XC27x5X Derivatives

16/32-Bit Single-Chip Microcontroller
with 32-Bit Performance

Errata Sheet

V1.5 2013-02

Figure 1 Context Switch with Pointer Passing in R15

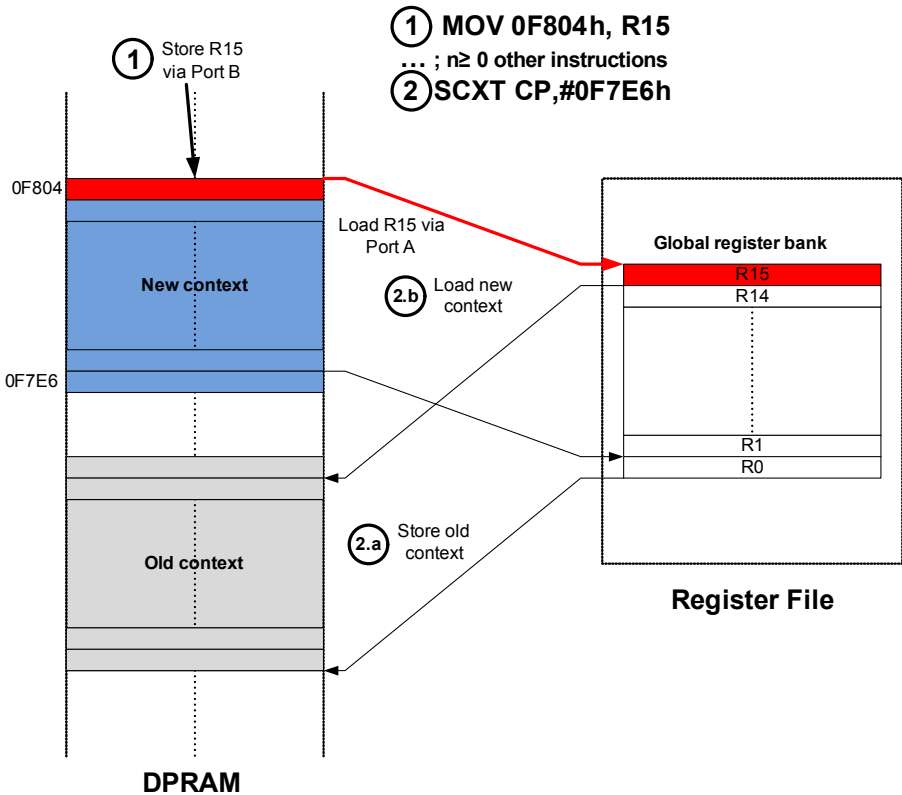
Scenario 1 (Context Switch)

In this scenario, the problem may occur under the following sequence of conditions (all conditions must be met):

1. L_1 and/or L_2 are located in the DPRAM in an area that is used to store the context of a global register bank, and

2. An explicit software write operation (i.e. no context switch) to L₁ and/or L₂ is performed, and
3. The Context Pointer (register CP) is modified (e.g. by MOV/POP/SCXT CP, ...) in one of the following instructions, leading to a context store (old context) and a context load (new context) of the global bank into/from DPRAM, and
4. One of the General Purpose Registers Rx with an odd register number x (x = 1, 3, ..., 15) is loaded from locations L₁ or L₂.

In this case, the contents of Rx may be incorrect.

This scenario may typically occur at the beginning of interrupt routines when a GPR (e.g. R15 used as user stack pointer) is saved into the new GPR context in DPRAM, as shown in the following **Figure 1**.

Workaround (Scenario 1)

- On **assembler** level, do not perform a context switch of the global register bank in case locations in the DPRAM corresponding to the location of a register Rx with an odd register number are written by software (see example for critical scenario in [Figure 1](#)).
- With the **compiler** of the TASKING VX-toolset, do not use the `__registerbank(...)` function qualifier to define a **global** register bank.
- With the **compiler** of the “Classic” TASKING C166/ST10 toolset, no workaround for this scenario is required (see analysis above).
- With the **compiler** of the Keil C166 toolset, no workaround for this scenario is required (see analysis above).

Figure 2 Critical application reset sequence

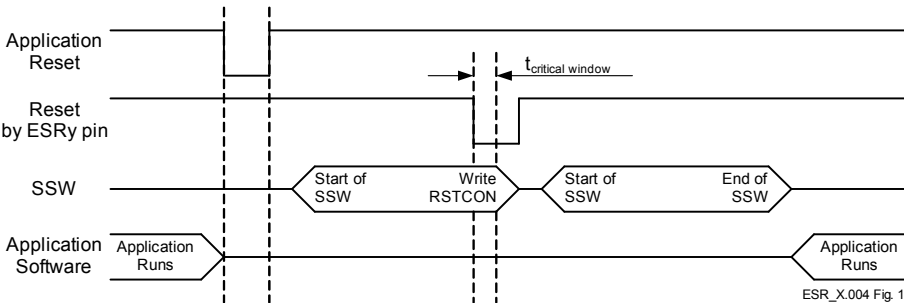
ESR_X.004 Wrong Value of `SCU_RSTCONx` Registers after ESRy Application Reset

`SCU_RSTCONx` registers are reset only by Power-On, but they may be wrongly affected after a second application reset requested by an ESRy pin. This may lead to the `SCU_RSTCONx` register values being set to zero, which could unexpectedly disable reset sources within the user application. The conditions which lead to this behavior are:

1. First, an application reset by SW (software), CPU (Central Processing Unit), MP (Memory), WDT (Watchdog Timer) or ESRy (External Service Request y) occurs.
2. Following this, an application reset on an ESRy pin occurs.
3. If the above mentioned ESRy reset occurs during a critical time window of the SSW (startup software), then it's possible that the application will operate with the wrong `SCU_RSTCONx` register value. The critical time window occurs when the SSW is writing the `SCU_RSTCONx` registers, and at the same time, the ESRy reset request is processed by the reset circuitry. The width of this critical window $f_{\text{critical window}}$ is less than 13 cycles.

- Initialize `SCU_RSTCONx` registers by user software after any reset, or
- assure that a second application reset request with an ESR pin does not occur during the critical time window.

Figure 3 Example for a Slow Input Signal

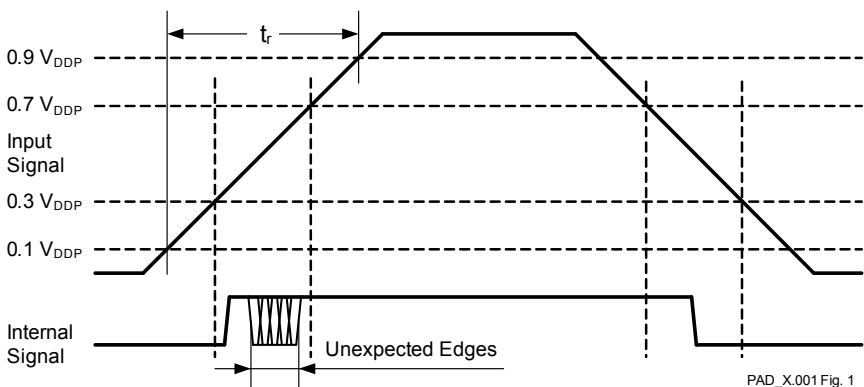
The digital input- and I/O-pins are designed using Schmitt trigger input structures with hysteresis. Even with this structure, it is possible that very slow rising edges may generate spikes, resulting in unexpected additional edges at the input signal.

The next picture **Figure 3** is an example for a slow input signal, with spikes shown on the slow rising input signal.

The first rising edge in **Figure 3** of the internal signal is always valid. The edges which are marked with “Unexpected Edges” must be ignored.

Use rising edges with faster rising slope t_r than defined in [Table 11](#).

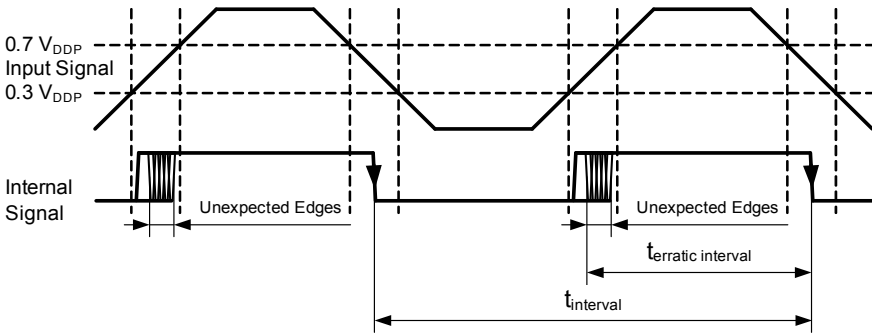
3. Workaround for Port Inputs

1. The captured time interval value should be checked whether it is in a reasonable range.
2. The input pin should be read several times, and a majority decision may be made to decide whether the edge was correct or erratic.

Only if 1) and 2) indicate that the edge was reliable, the captured value should be used for further calculations. Otherwise, a substituted (extrapolated) value might be used.

Figure 5 Rising Edge Detection Approach

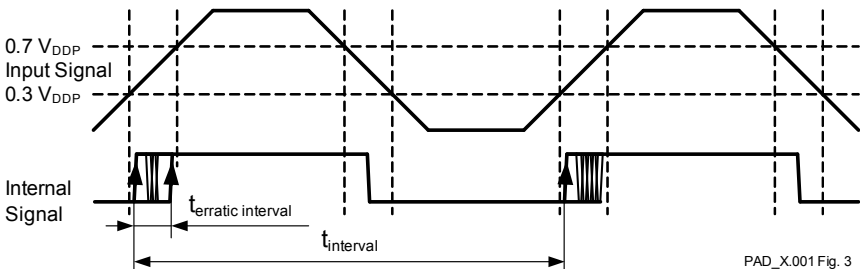
In case of rising edge detection multiple interrupts would be generated when the spike occurs. The time interval since the last interrupt can be measured – if it is very small compared to the expected value, this would indicate a spike and the interrupt should be ignored.

If the time between the rising signal edge and the rising edge caused by a spike $t_{erratic}$ is less than the ISR service time, a workaround would be to clear the

interrupt request (IR) flag before the return from interrupt is done. The clearing of the IR flag will avoid a further erratic interrupt.

The preferred solution for interrupt handling is to use the rising edge detection.

Figure 6 Rising Edge and Falling Edge Detection Approach

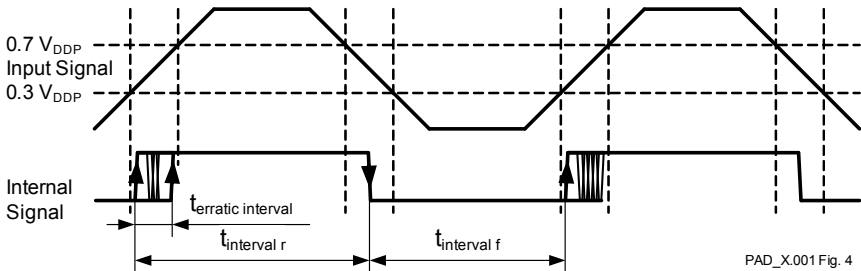
The rising edge detection workaround works also if both edges are used as trigger for interrupt and the following conditions are valid:

- $t_{\text{erratic interval}} \ll t_{\text{interval r}}$ and
- $t_{\text{erratic interval}} \ll t_{\text{interval f}}$
